RE: Preliminary Plan Letter Preliminary Plan No. 120160190 Ripley II

> RE: Preliminary Plan # 120160190 Ripley II Traffic Impact Study Review

Re: Fire Department Access Plan Revision Ripley II Ripley Street and Dixon Avenue Silver Spring, Montgomery County, MD BEPC # MB122050

• One (1) copy of the Revision to Approved Fire Department Access Plan Exhibit.

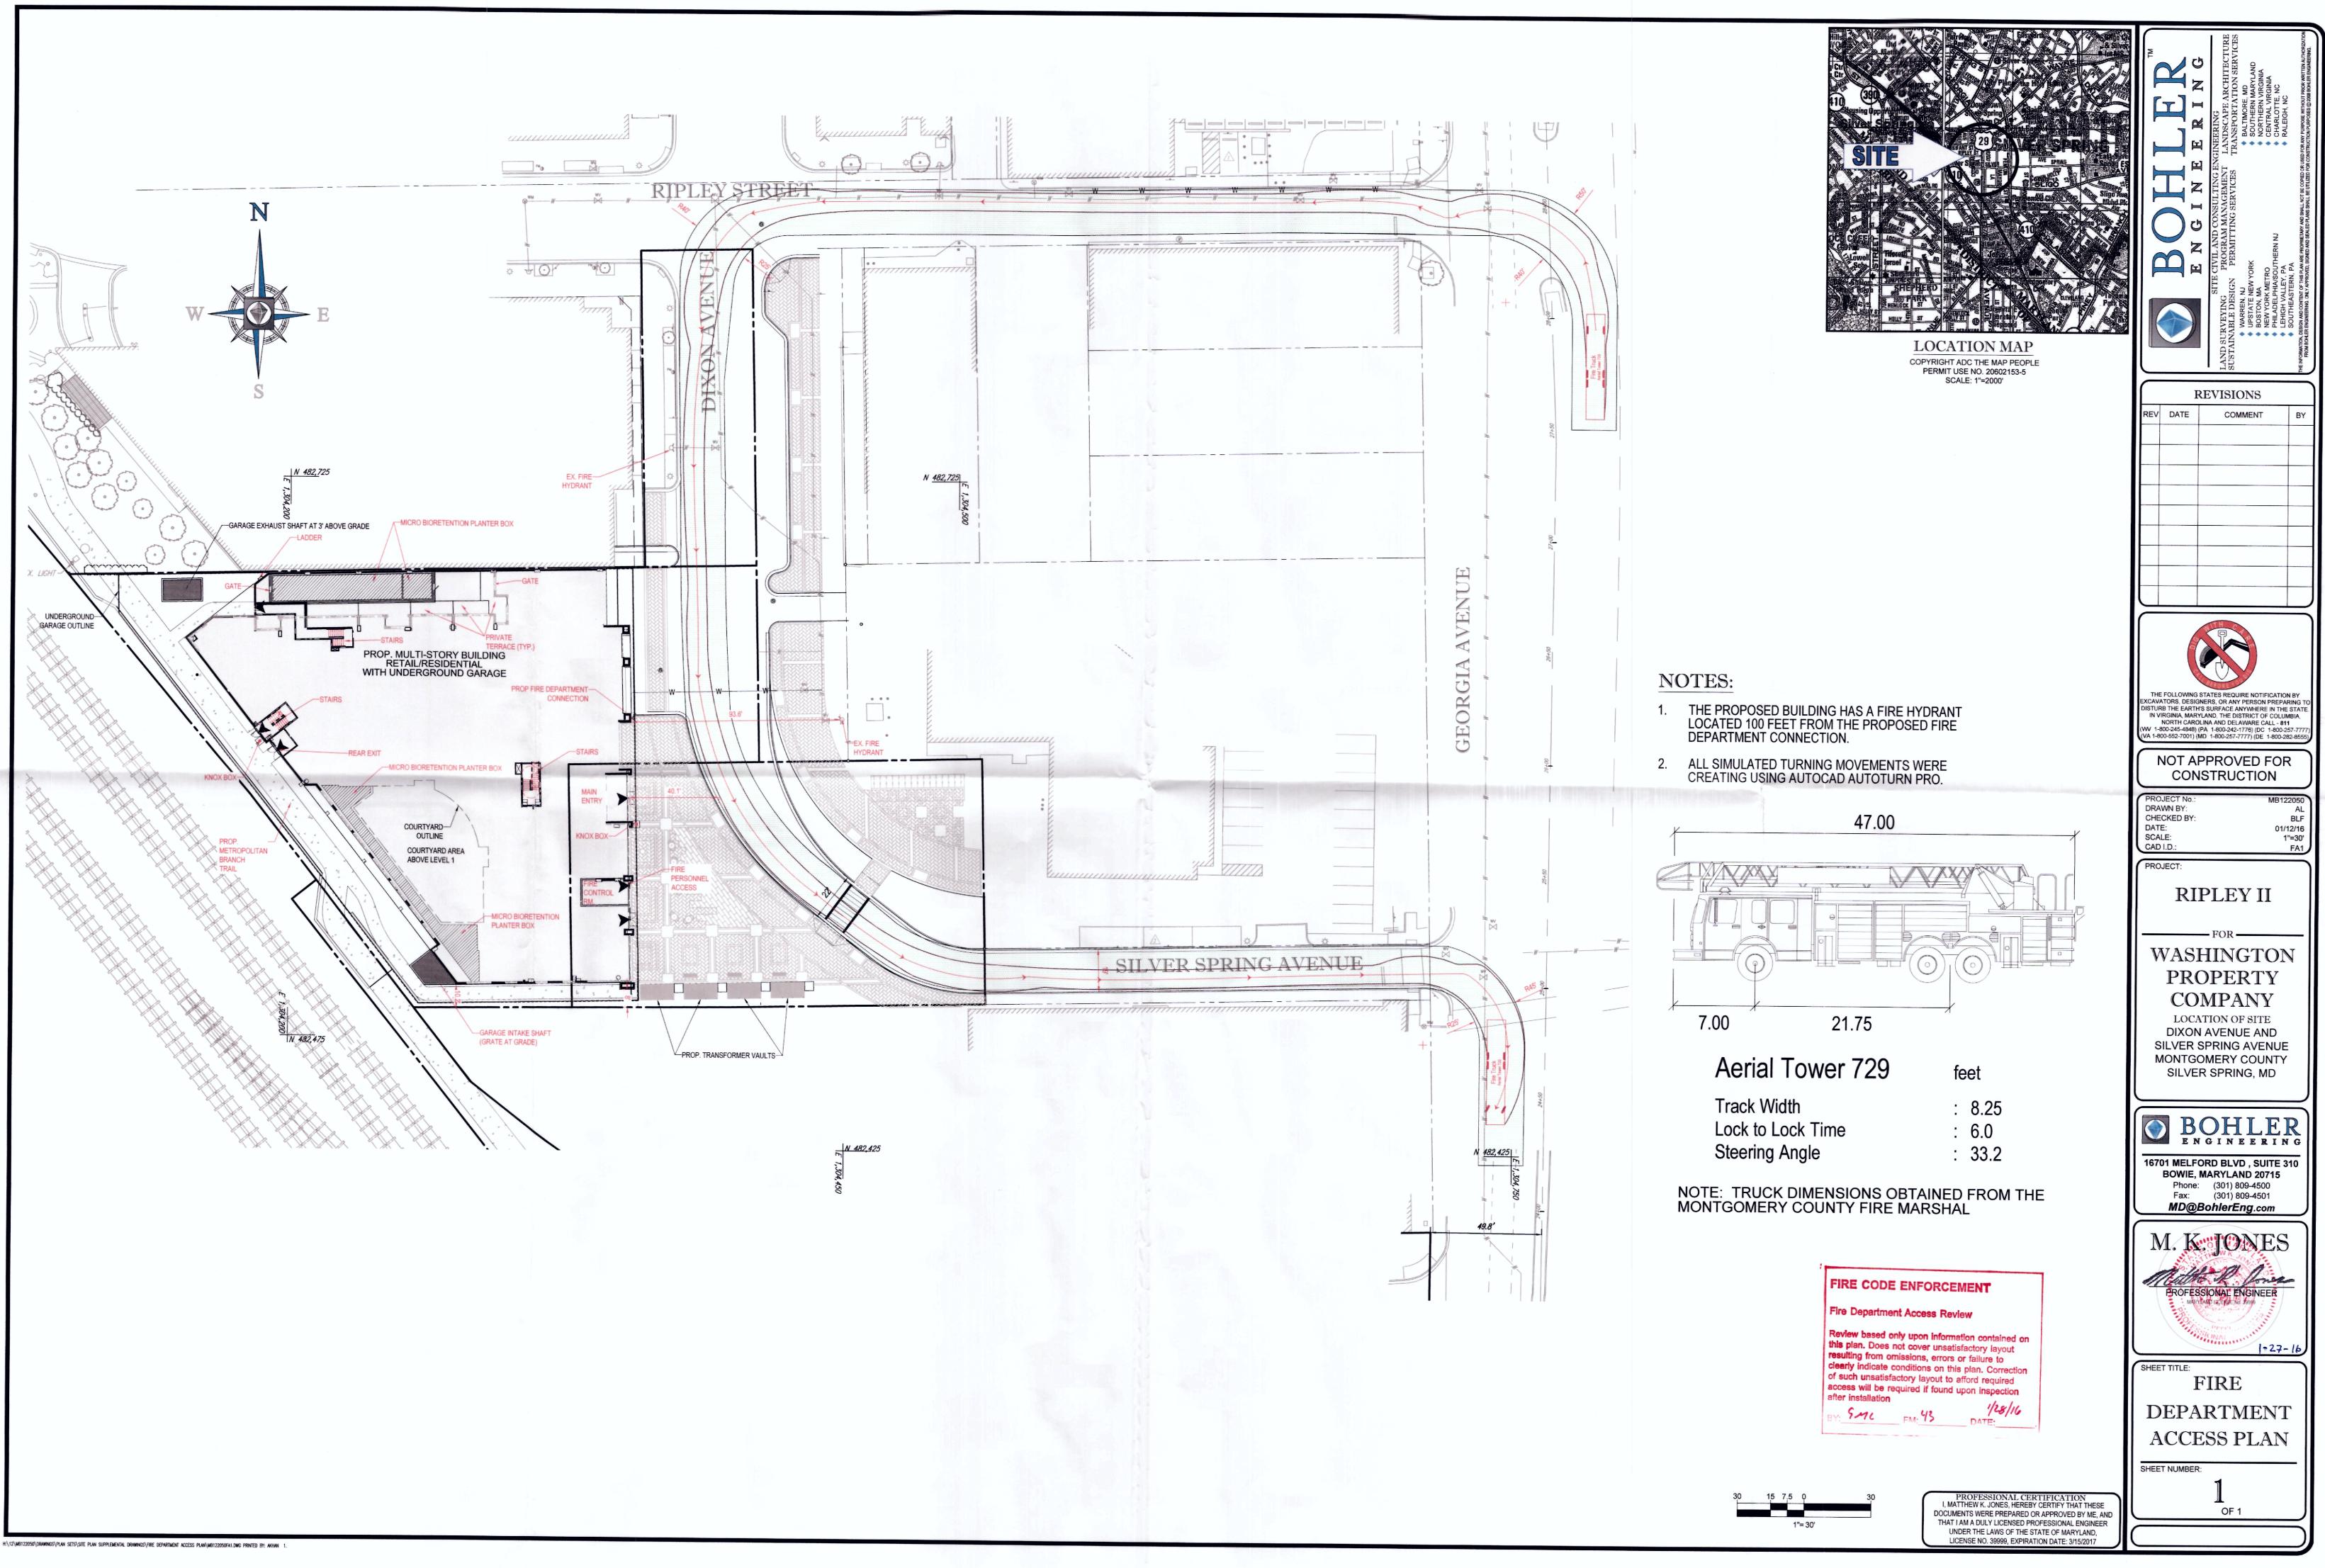
On behalf of Ripley West, LLC, Bohler Engineering is pleased to present this Fire Department Access Plan revision for your review and approval. The Fire Department Access Plan for the Ripley II project was previously approved on January 28, 2016. Per Montgomery County Department of Permitting Services Water Resources Division, a stairway was requested to be added to provide access to the bioretention area on the terrace level between the Ripley I and Ripley II buildings.

The plans have been revised to show the proposed 48 inch wide stairway that will provide access for stormwater management inspection and also the ships ladder location. The proposed stairway is steel with a closed riser, due to constructability concerns concrete stairs were not feasible. Because of the steel stairs, the ships ladder remains as previously approved, in addition both accesses are within a gated area with a Knox Box.
